SHELBY COUNTY
HIGHWAY DEPARTMENT
506 HIGHWAY 70
COLUMBIANA, ALABAMA 35051
(205) 669-3880
www.ShelbyAL.com

PROJECT NO. SCP 59-959-24
ADDENDUM NO. 2

TO: Prospective Bidders
FROM: Mark Endfinger, P.E.
Chief Engineer

PLAN & ELEVATION

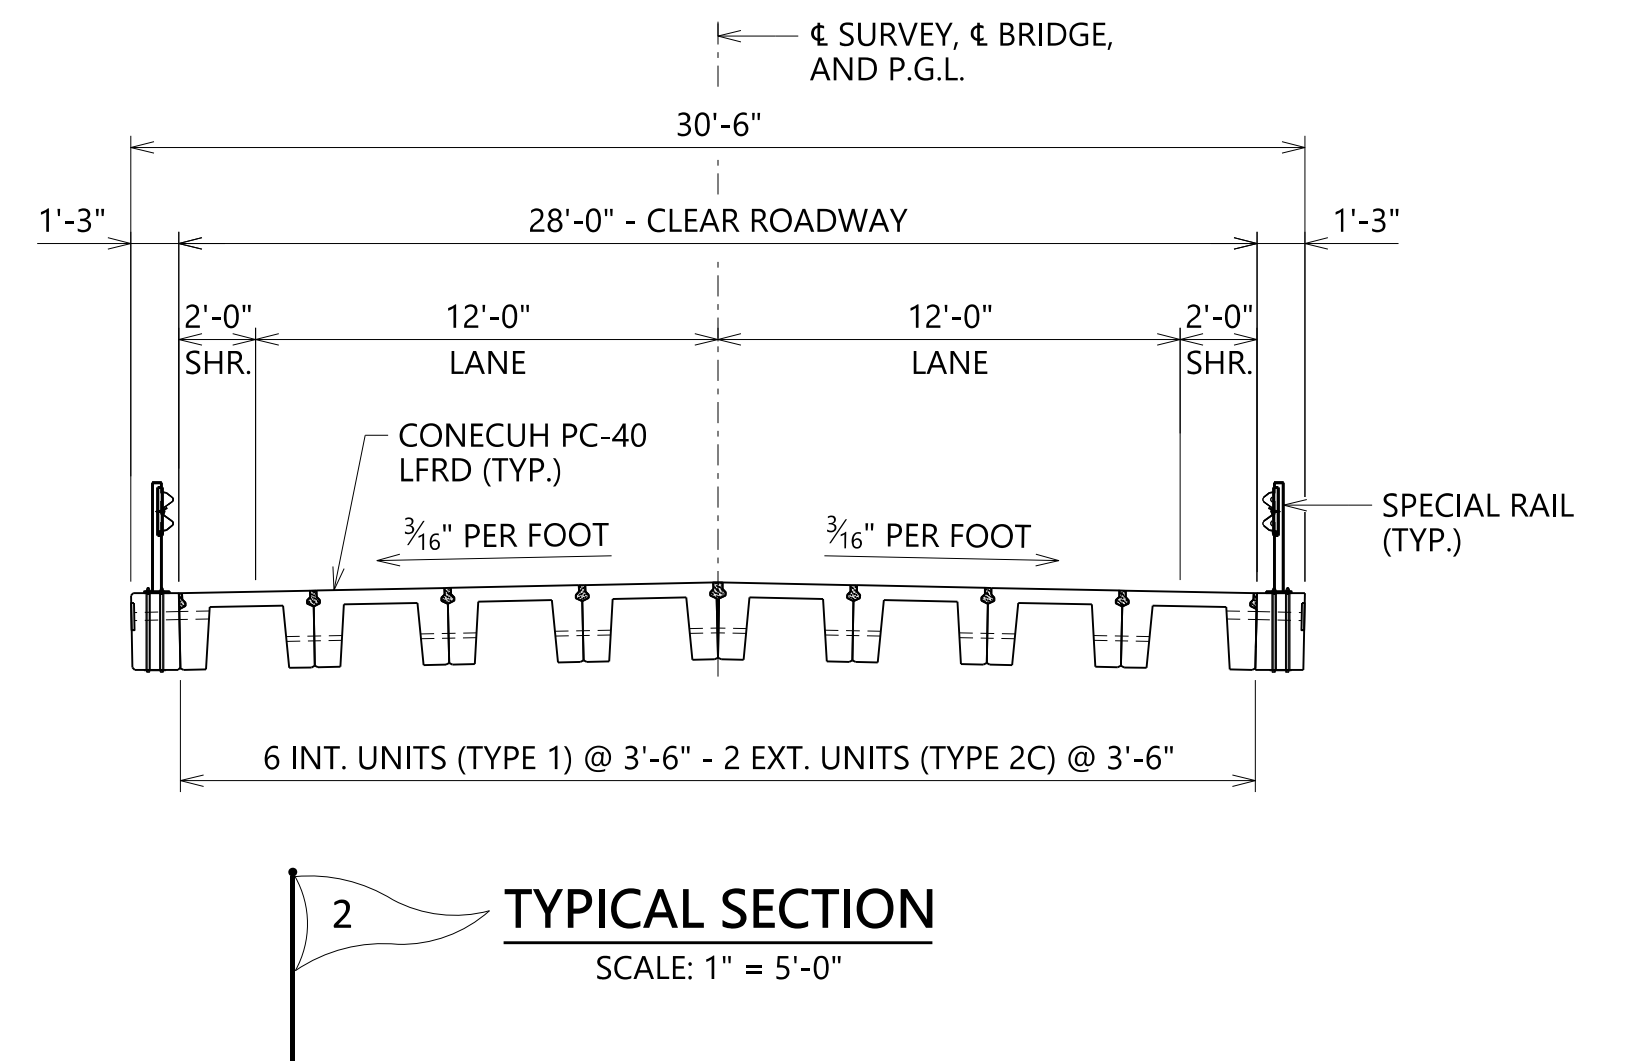
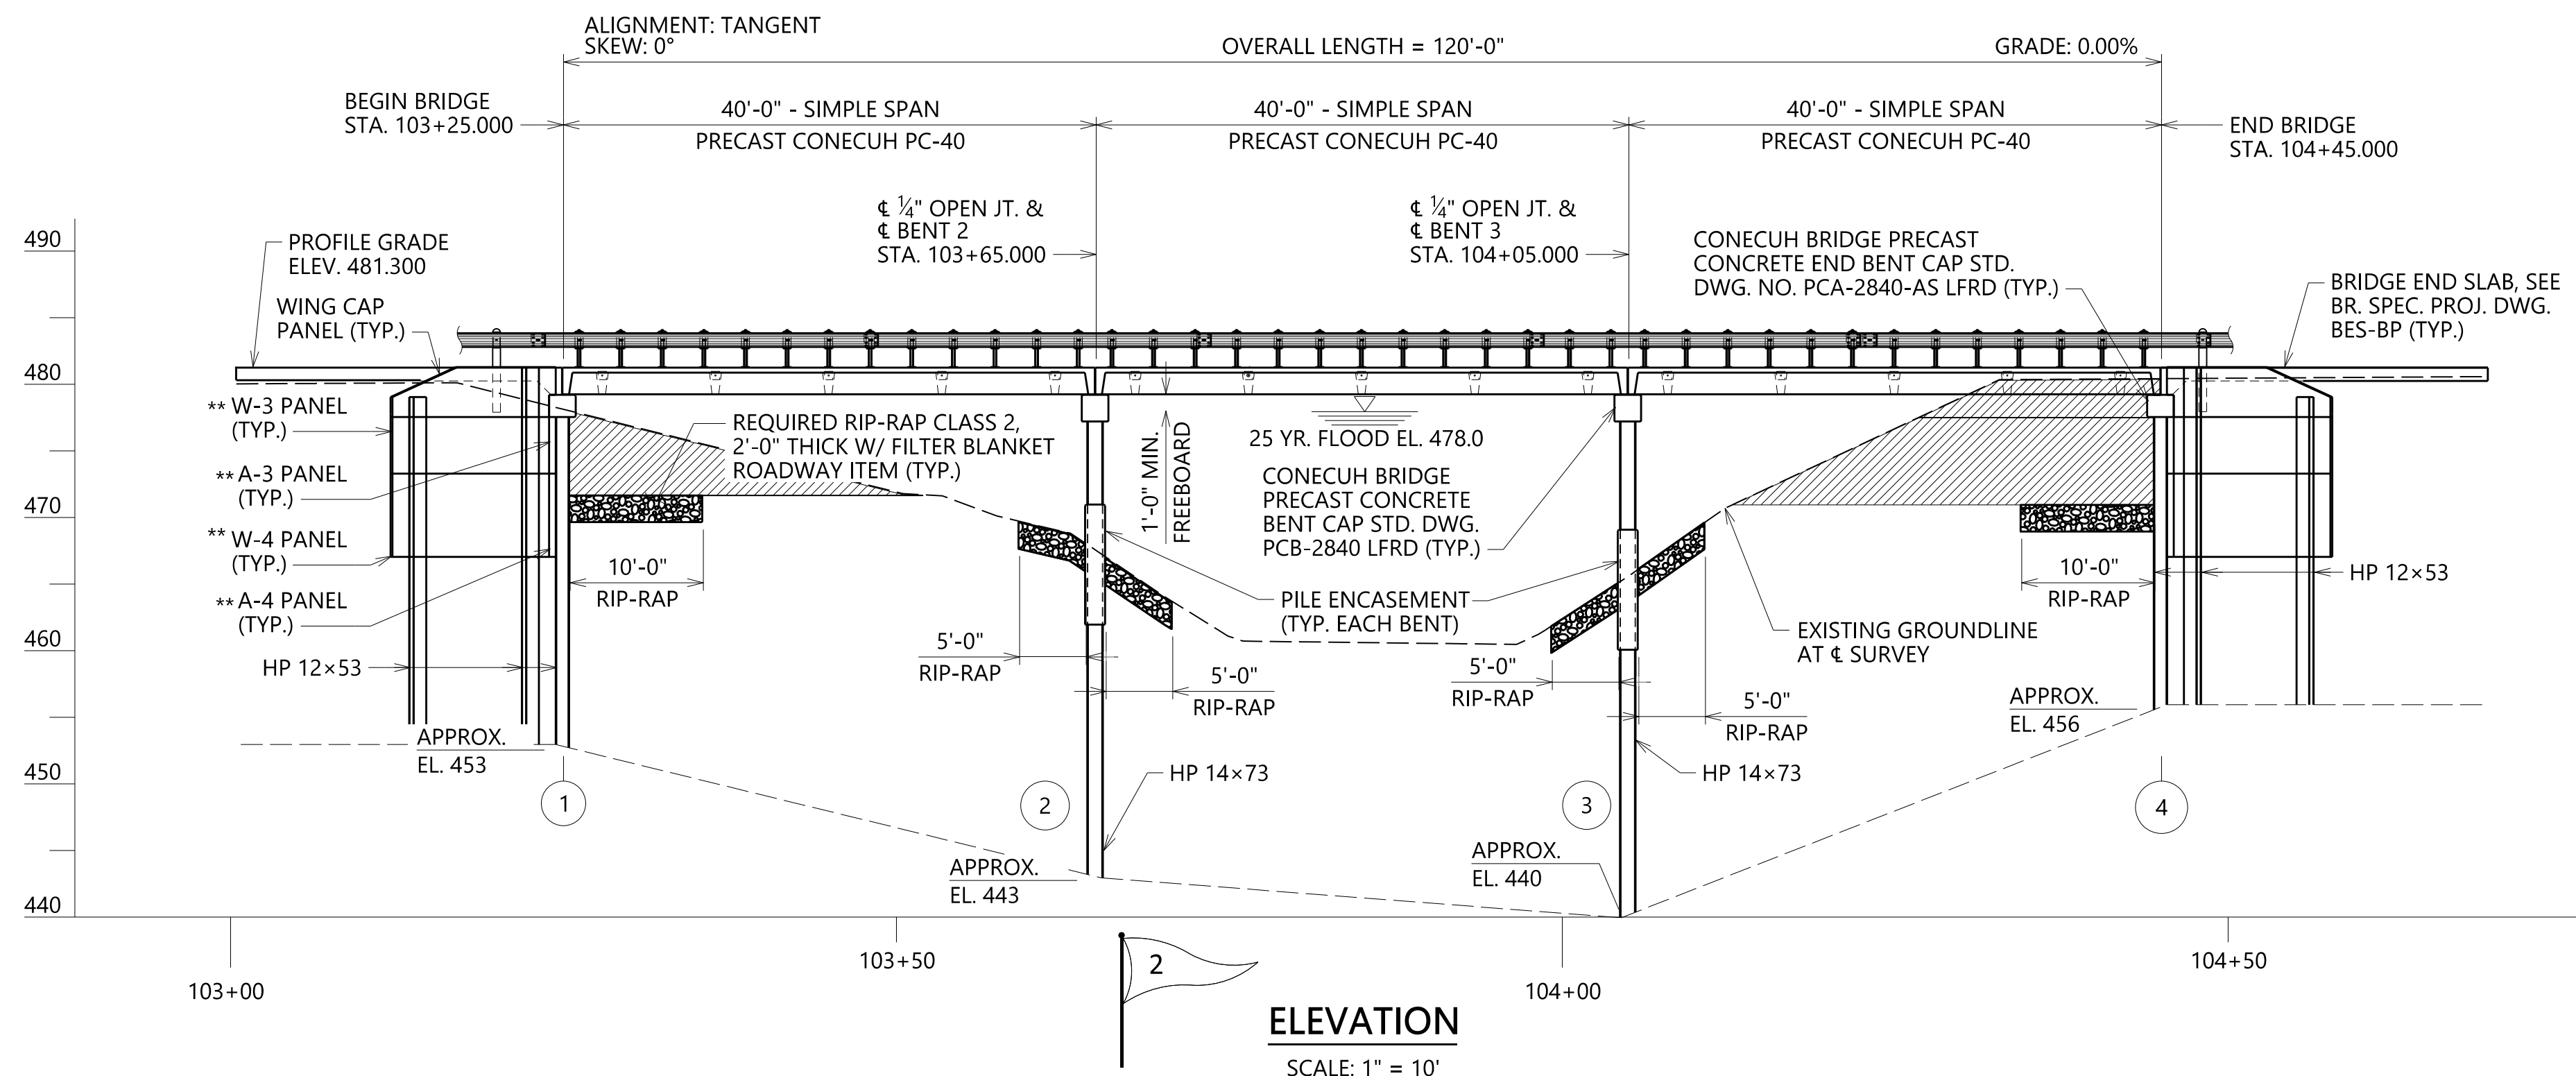
Q1 – Can equivalent precast bridge elements be allowed for the specified Conecuh precast concrete elements in the plans?

A1 – Equivalent elements will be allowed per special note 9 on REVISED sheet 60 and note 5 on REVISED sheet 61.

- 1.) ADDITIONALLY, COST OF REMOVAL AND DISPOSAL OF EXISTING RIP-RAP, SUBSTRUCTURE UNITS, AND PILES THAT INTERFERE WITH NEW CONSTRUCTION SHALL BE INCLUDED IN PAY ITEM 206A000, REMOVAL OF OLD BRIDGE.
- 2.) COST OF LOOSE RIPRAP SHALL BE PAID FOR BY ITEM NO. 610A004.
- 3.) NO SUBSTITUTIONS OF ALTERNATE SPAN ARRANGEMENTS SHALL BE ALLOWED.
- 4.) WING PILES SHALL BE DRIVEN TO REFUSAL OR 20', WHICHEVER IS LESS. THE MINIMUM PENETRATION FOR WING PILES SHALL NOT BE LESS THAN 10 FEET INTO NATURAL GROUND. ALL OTHER STEEL PILES SHALL BE DRIVEN TO REFUSAL.
- 5.) BRIDGE PLANS DEVELOPED BASED ON CONECUH PRECAST BRIDGE STANDARDS. CONTRACTOR MAY SUBMIT ALTERNATIVE PLANS THAT MEETS/EXCEEDS PROJECT REQUIREMENTS FOR BID.

SPECIAL RAIL DETAILS

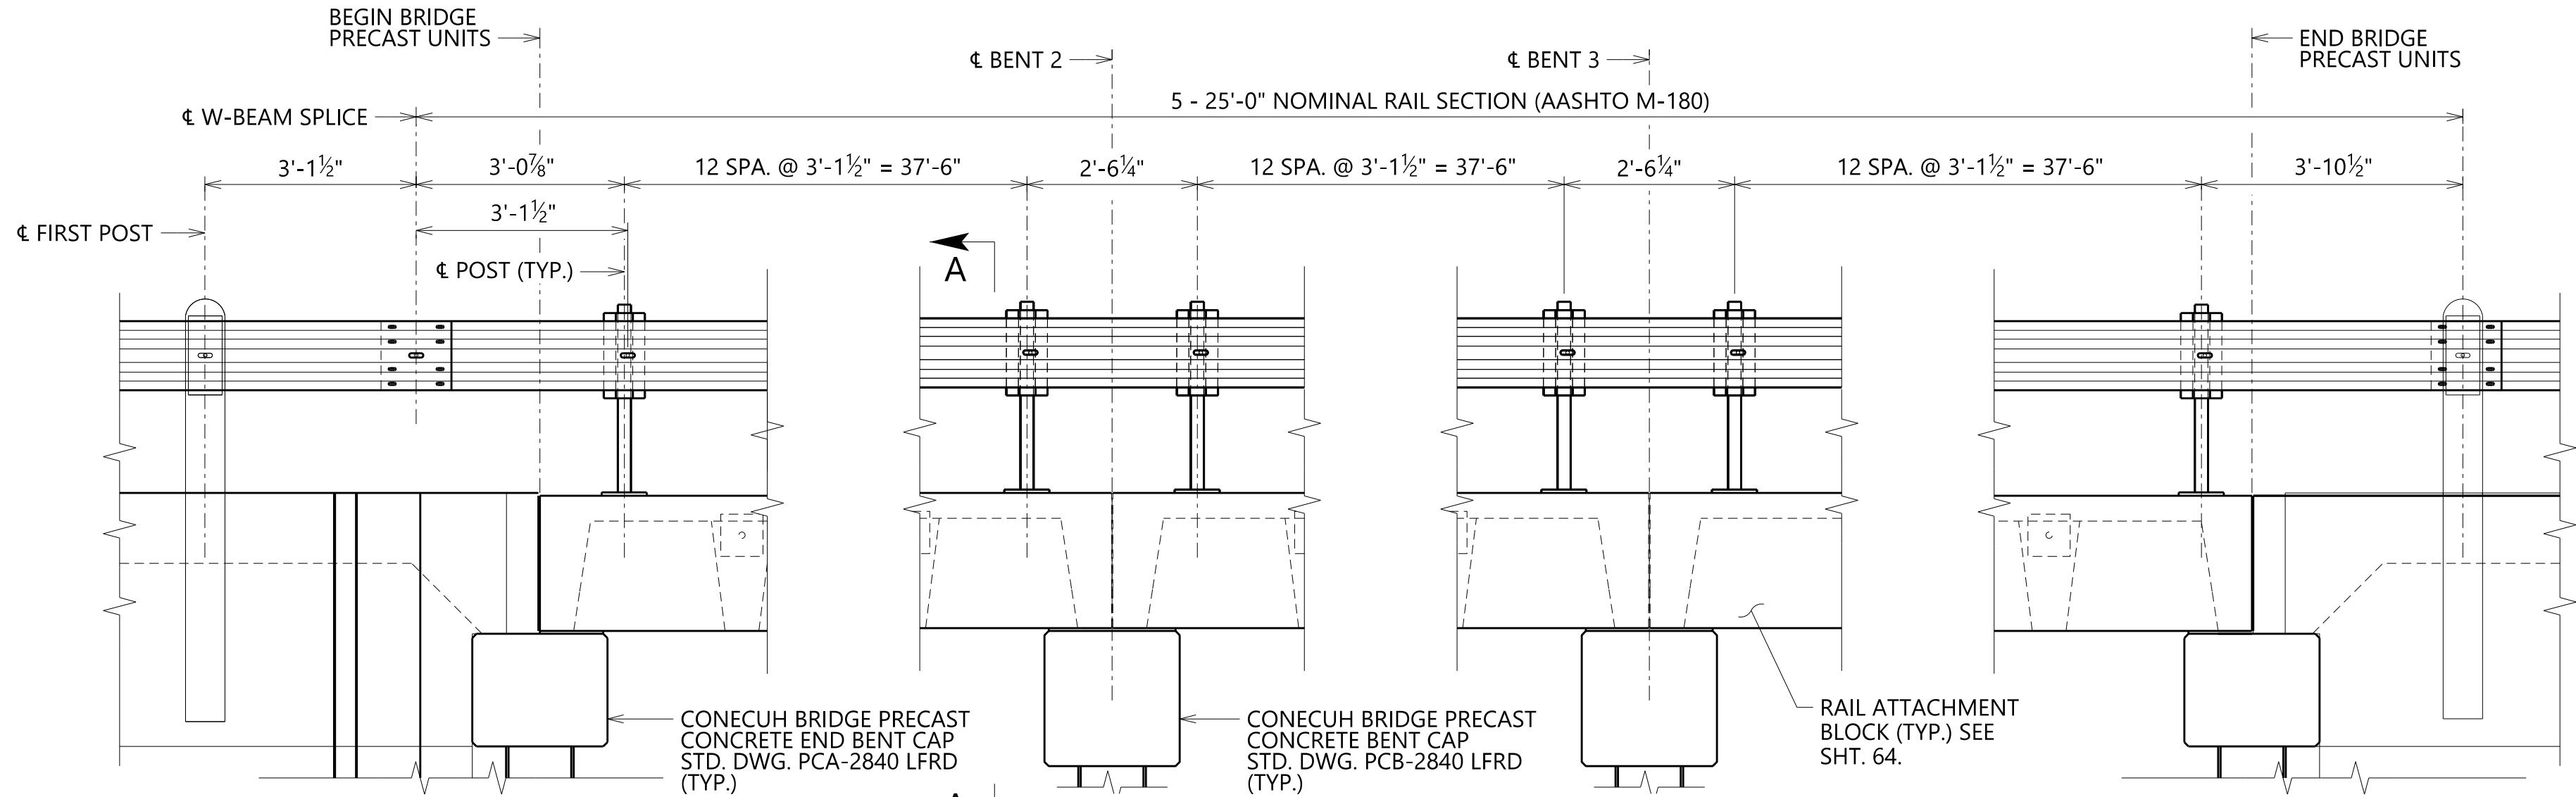
Q6 – It appears that the mounting for the rail to the rail block may be in conflict with the abutment or caps.

A6 – See REVISED sheet 62. A note has been added to allow the posts to be adjusted in order to avoid bearing issues.

NOTE: IF ADJUSTING OF POST LOCATIONS ARE REQUIRED, MAINTAIN A MINIMUM 9" FROM CL OF POST TO NEAREST EDGE OF JOINT AND A MAXIMUM POST SPACING OF 3'-1 1/2". DRILL NEW 3/4" DIAMETER HOLE AT THE CENTERLINE OF W-BEAM FOR SHIFTED POST. PAINT HOLE WITH TWO COATS OF ZINC-RICH PAINT CONFORMING TO THE ITEM "GALVANIZING". ALL OTHER POSTS MUST REMAIN ON THE SPACINGS AS SHOWN IN PLANS. POSTS MAY BE ADJUSTED TO AVOID BEARING ISSUES.

REFERENCE PROJECT NO	FISCAL YEAR	SHEET NO
SCP 59-959-24	2026	63

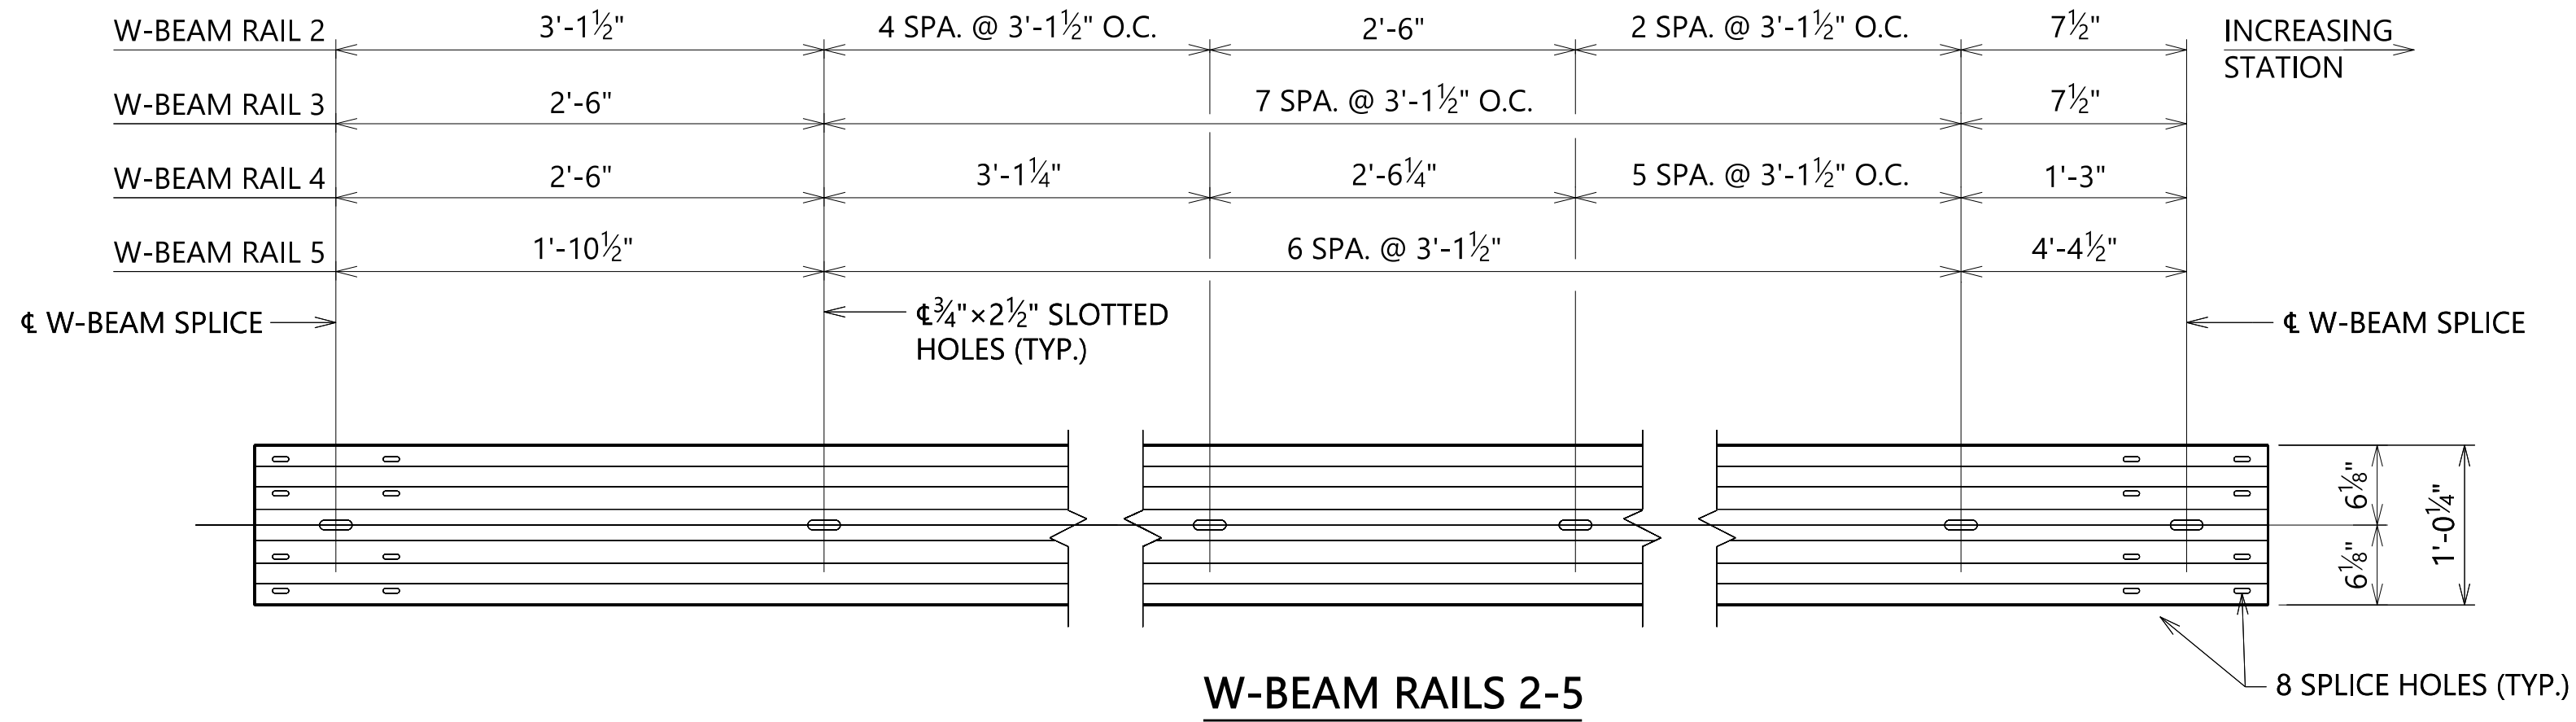
Q3 – Sheet 60 Note 7 and Sheet 63 Note 8 are in conflict regarding the payment for the rail block construction

- Note the changes to the W-BEAM RAILS 2-5 on REVISED sheet 63.
- Note the following on REVISED sheet 60:
"7" RISER BLOCK AND STEP SHOWN IN ASSOCIATED CONECUH PRECAST STANDARD DRAWINGS ARE TO BE OMITTED FROM PRECAST UNITS. INTENT IS FOR CUSTOM PRECAST RAIL BLOCK UNIT TO REST ATOP OF PRECAST SUBSTRUCTURE UNIT ON ½" TYPE 1 (60 DURO HARDNESS) ELASTOMERIC BEARING PADS"

A3 – The note from Sheet 63 note 8 has been REMOVED on REVISED sheet 63. The bill of reinforcement and estimated and concrete quantities have been adjusted and will be paid according to REVISED Sheet 60 Note 7.
